Appendix A:
Cordoba Center Project – Final EIR Research Items

December 3, 2018

Subject: Cordoba Center Project – Final EIR Research Items

Placement of New Wastewater Treatment Facilities

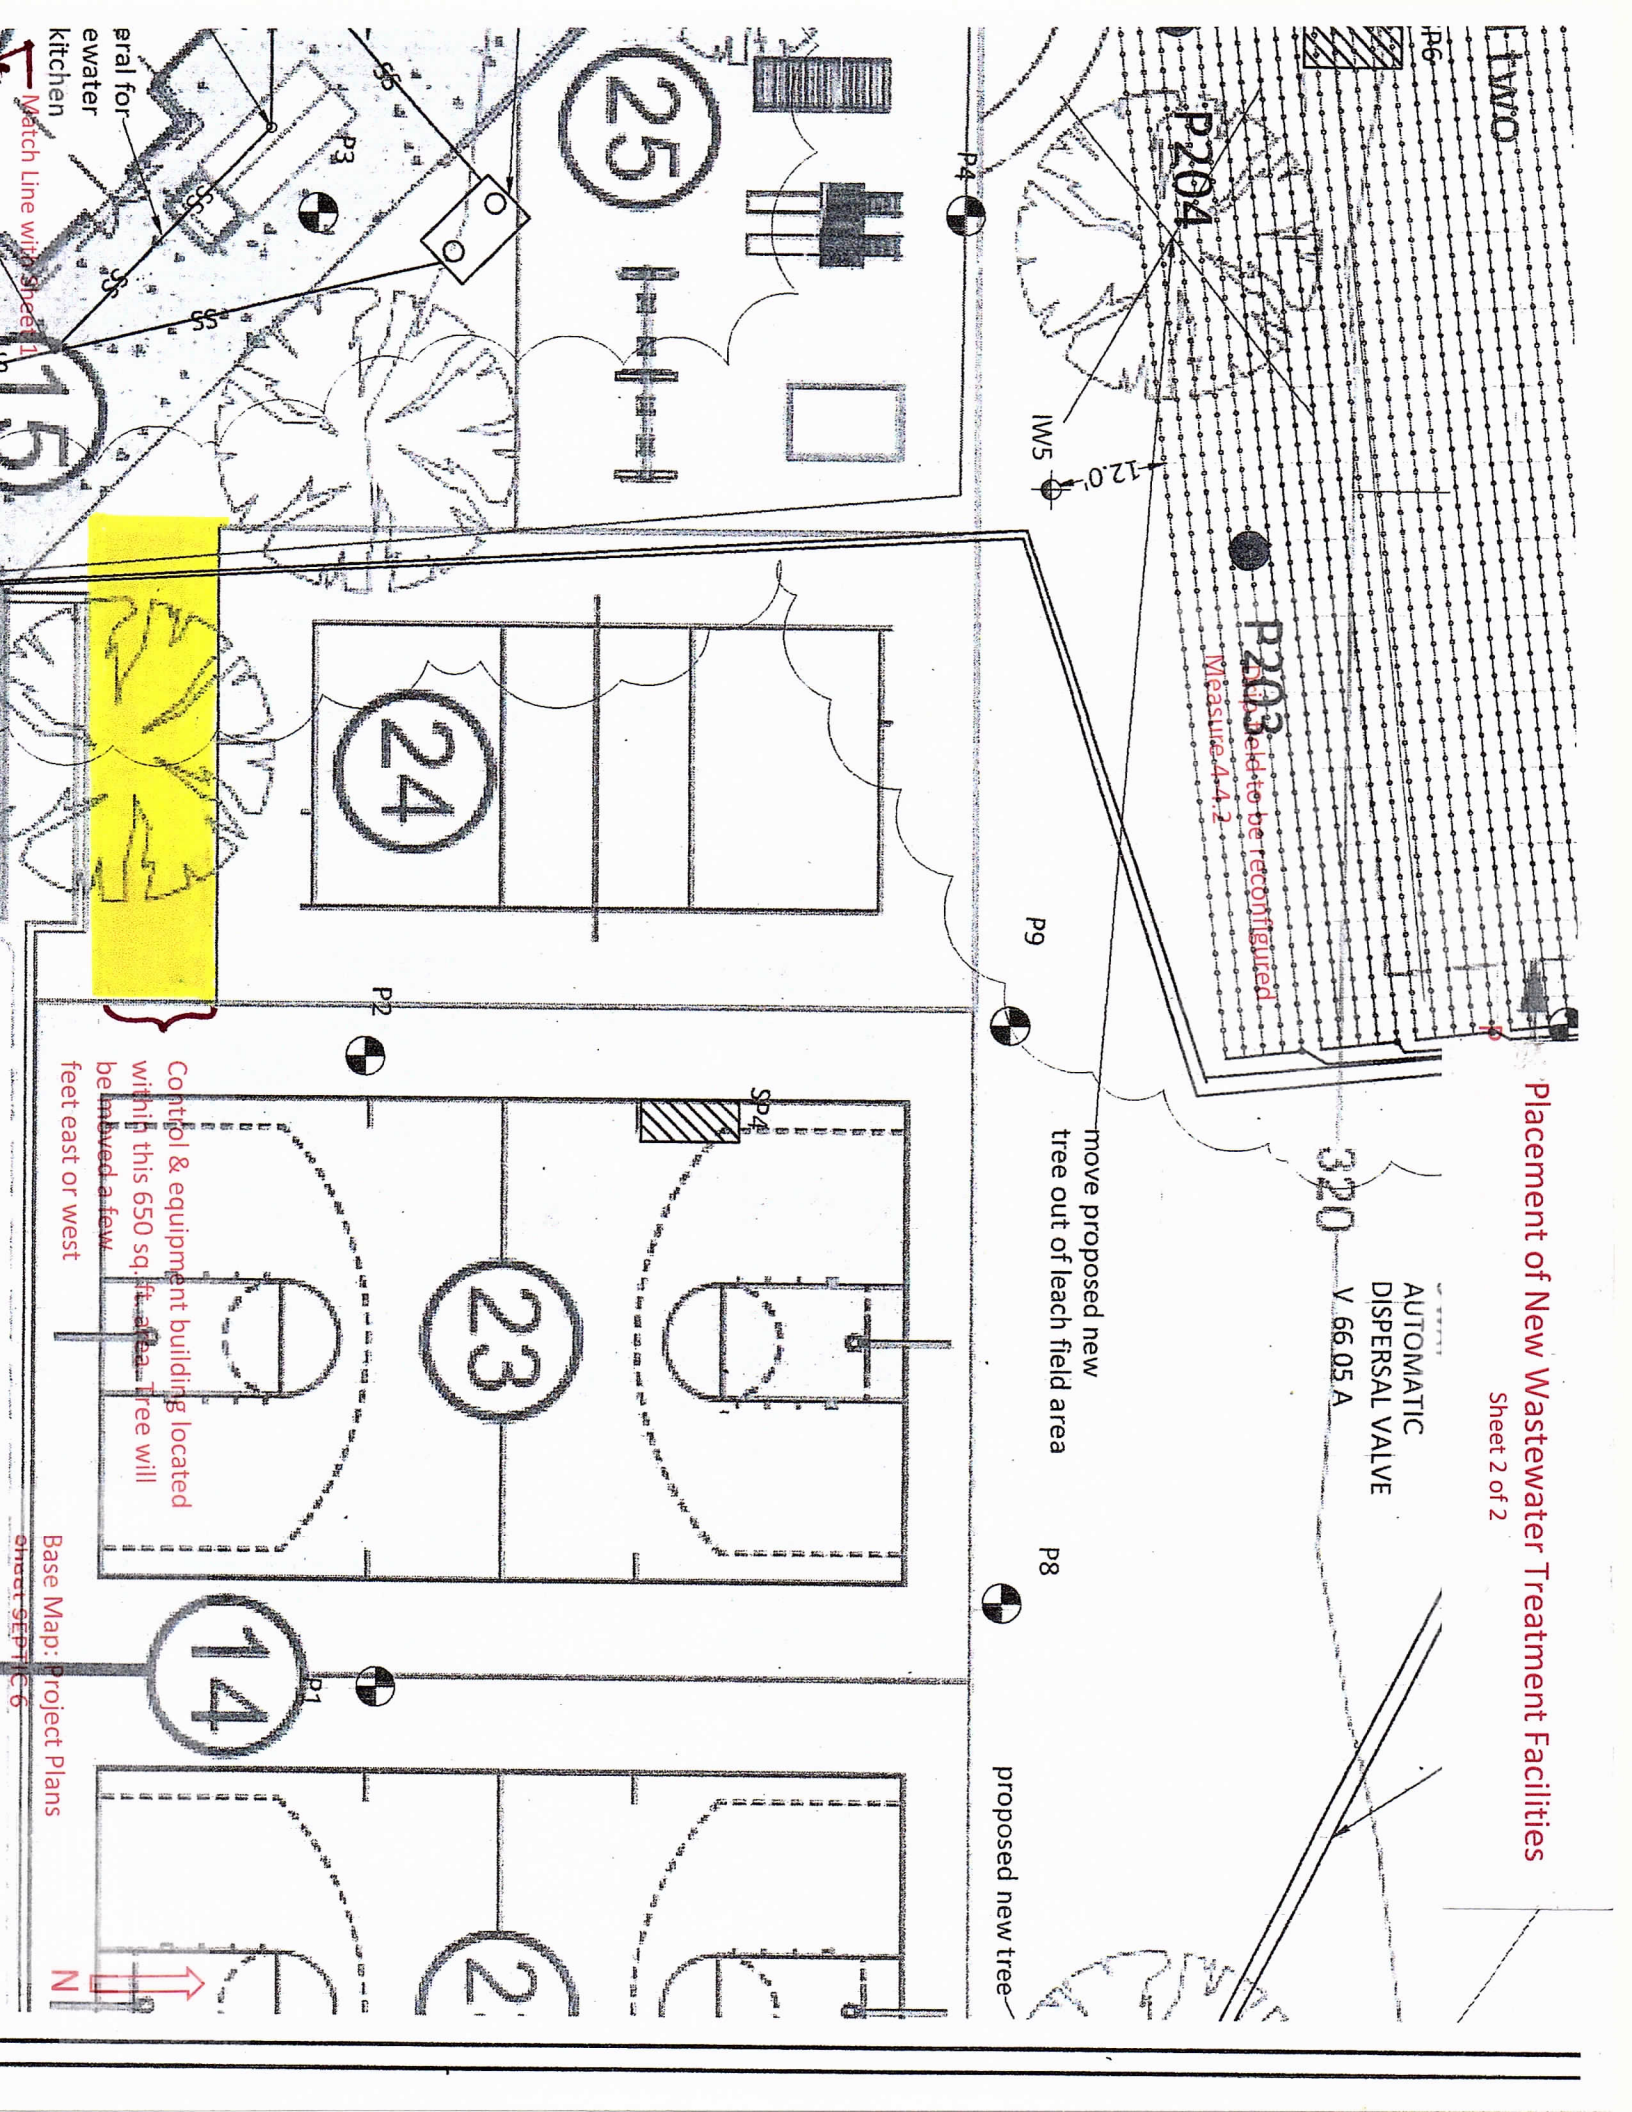
Live oak tree to be relocated northward and possibly replaced with another species.

Relocate pump chamber 10'-12 ft. northward.

MBBR unit located here (56 sq. ft.)

Remove and replace Multiflow treatment units with 4" SCHEDULE 40 pvc secondary & advanced secondary treatment units within this 500 sq. ft. area

Remove and replace Multiflow treatment units with 4" SCHEDULE 40 pvc secondary & advanced secondary treatment units within this 500 sq. ft. area

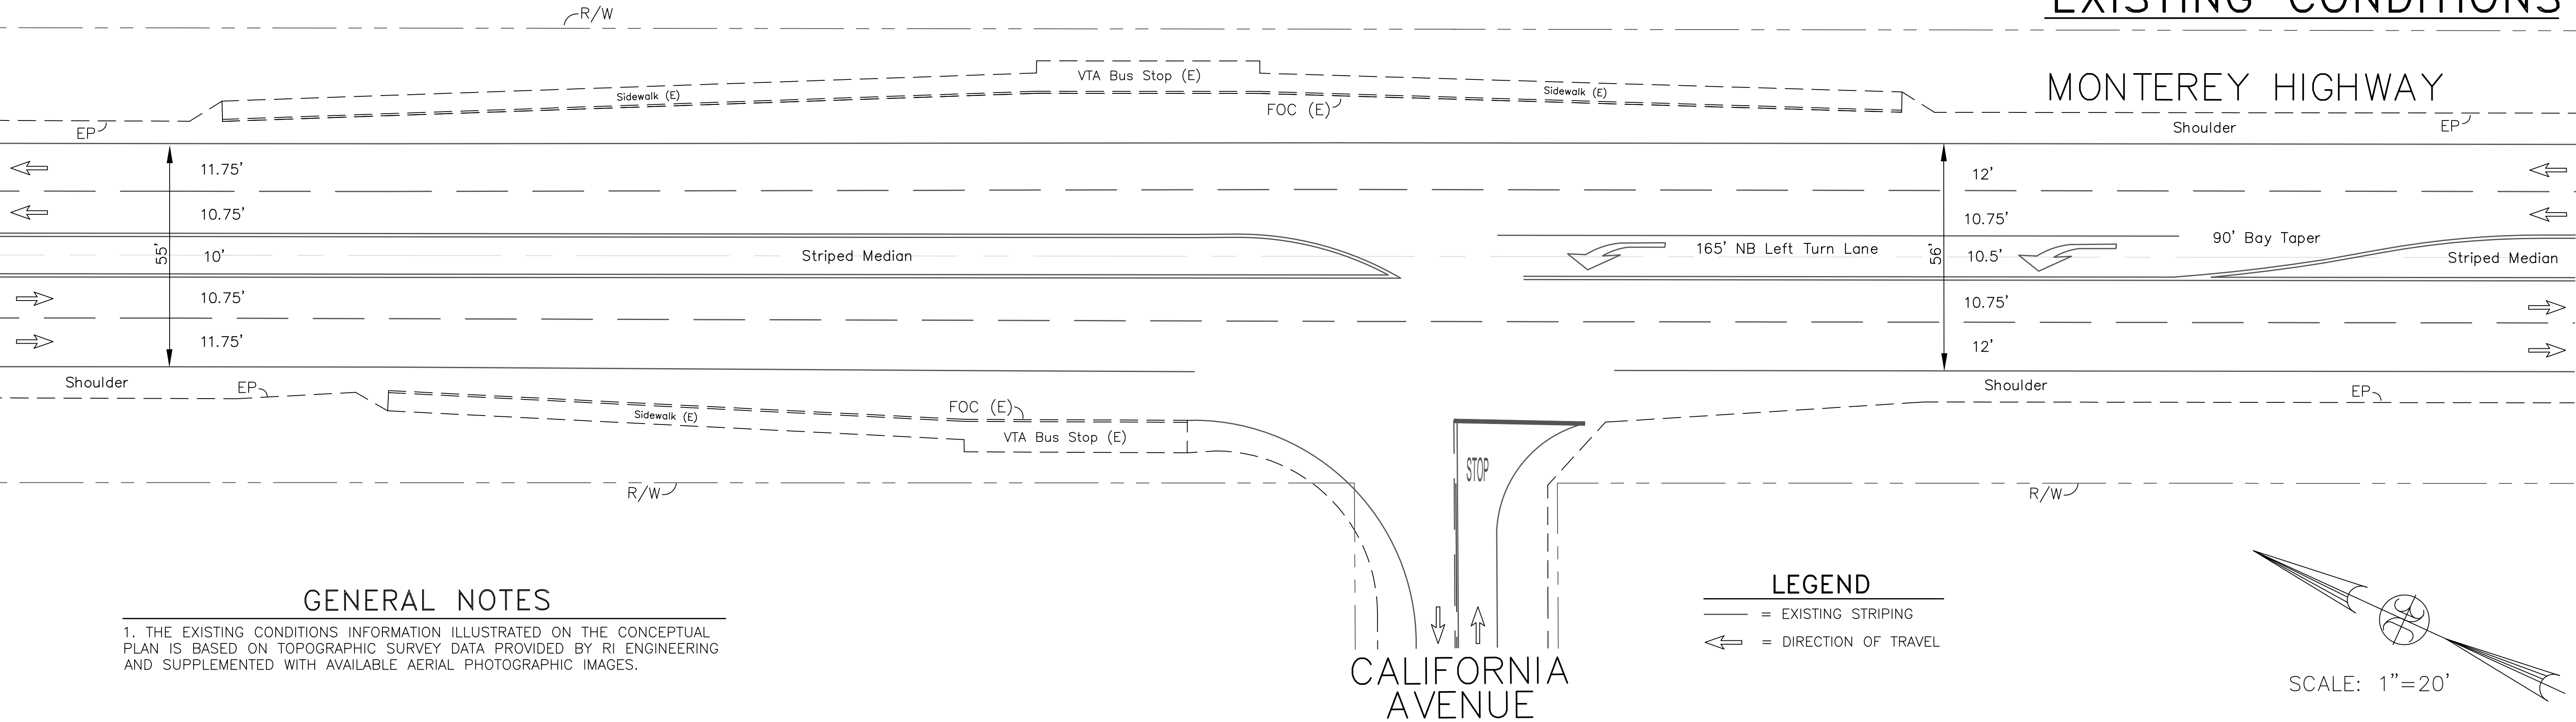
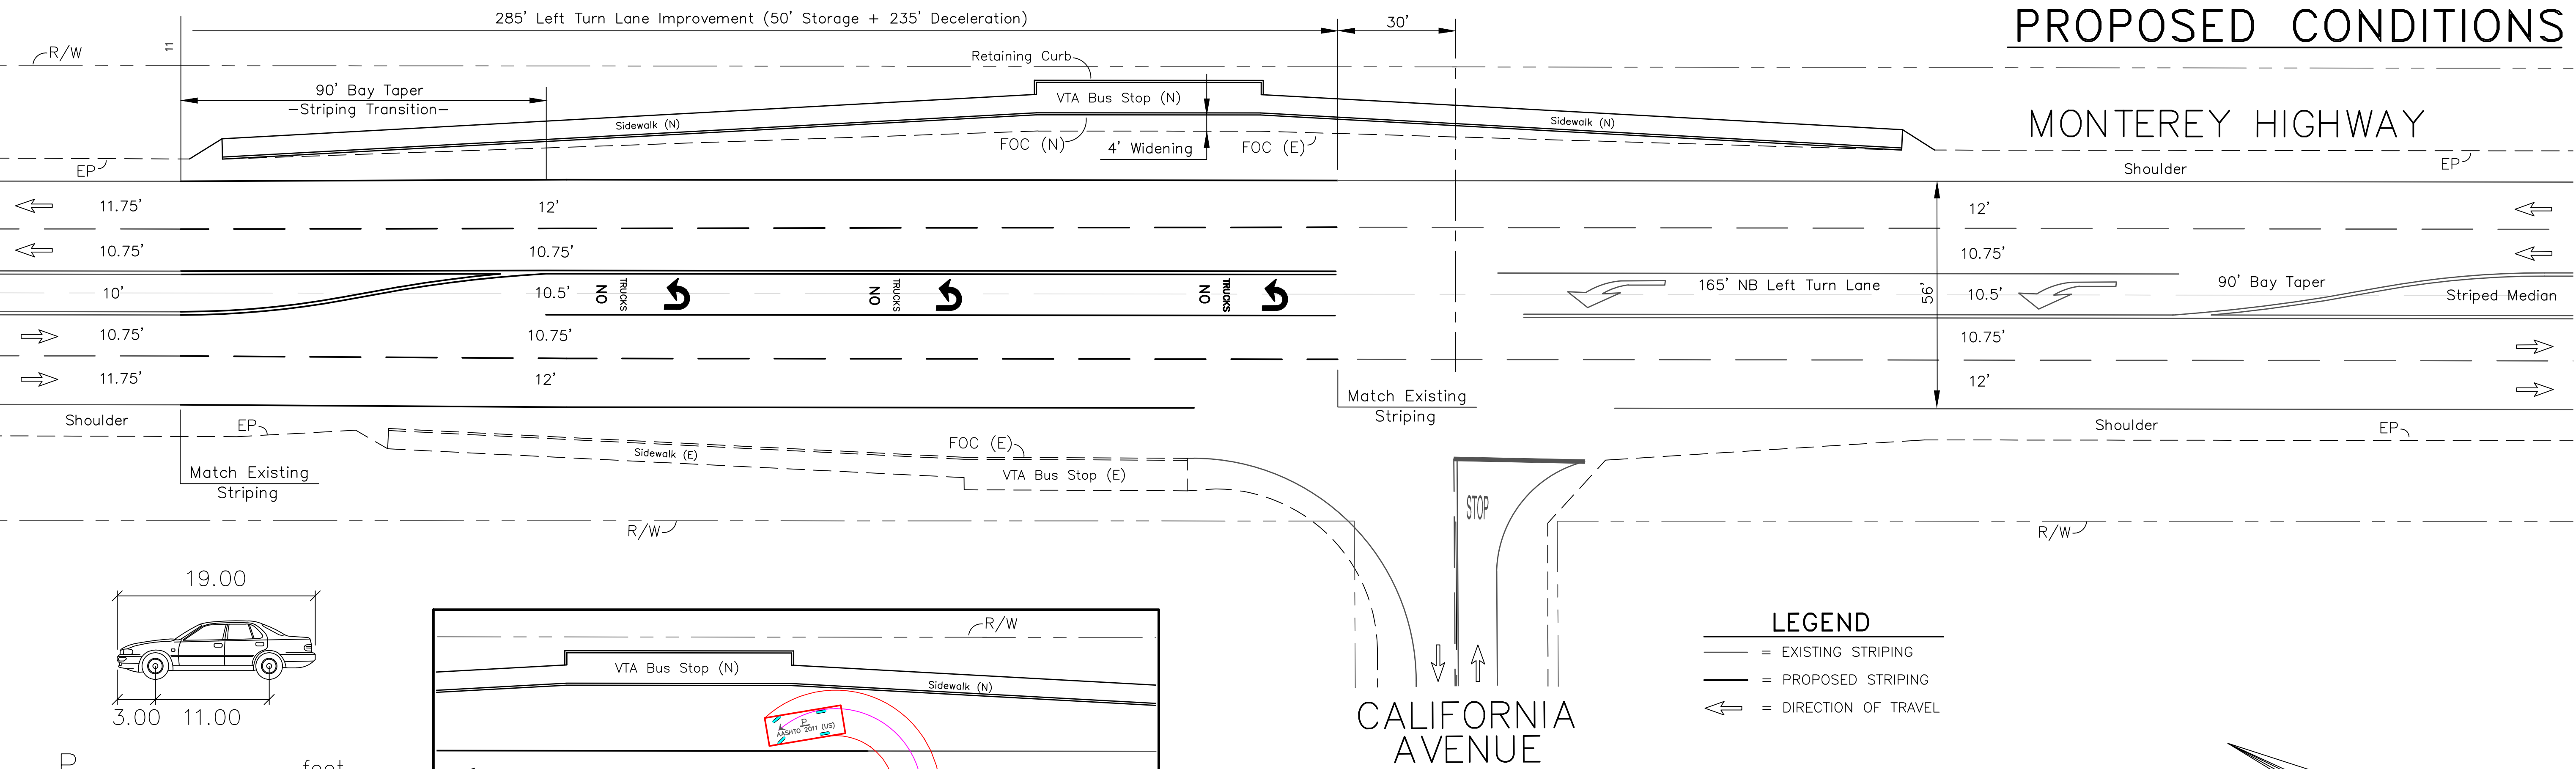
vehicle storage plus adequate room for vehicle deceleration (Table 405.2B). The queuing analysis demonstrates that vehicle storage should be provided for 2 vehicles (50'). Monterey Highway is posted with a 50 mile-per-hour (MPH) speed limit near the project site and California Avenue. The Caltrans HDM indicates the design speed for deceleration may be reduced by 10-20 MPH for a lower entry design speed. Since the project driveway will be located only about 650' north of California Avenue, it was deemed reasonable to use a 30 MPH entry speed. The southbound left turn lane improvements will need to be a total of 285' (50' storage + 235' deceleration).

A layout of the conceptual improvements for the southbound U-turn pocket (left turn lane) was developed using topographic survey data provided by RI Engineering and aerial photographic images. The Conceptual Plan illustrates the existing and proposed conditions (copy attached). Based on direction from County staff, the AASHTO standard passenger car turning template ($R=24'$) was used to determine if improvements would be required on Monterey Highway to accommodate the southbound U-turn movement. The proposed conditions illustrate that the VTA bus stop would need to be moved approximately 4' east to accommodate the southbound U-turn movement for a standard passenger car. County staff also requested that the turning template be performed for a standard delivery truck (e.g. 30' single unit). However, the turning radius for a 30' single unit truck is 42' which would require a turnaround diameter of 84'. This could not be constructed within the County right-of-way (ROW) and would impact the existing railroad tracks, which would not be physically or economically feasible. It's noted that any project related truck traffic will be able to use California Avenue-Santa Teresa Boulevard (local traffic) and San Martin Avenue-US 101 (regional traffic) for access to points north of the project site. It's also noted that any additional room for vehicle storage or deceleration will be able to be accommodated within the existing striping median north of the proposed southbound U-turn pocket (left turn lane).
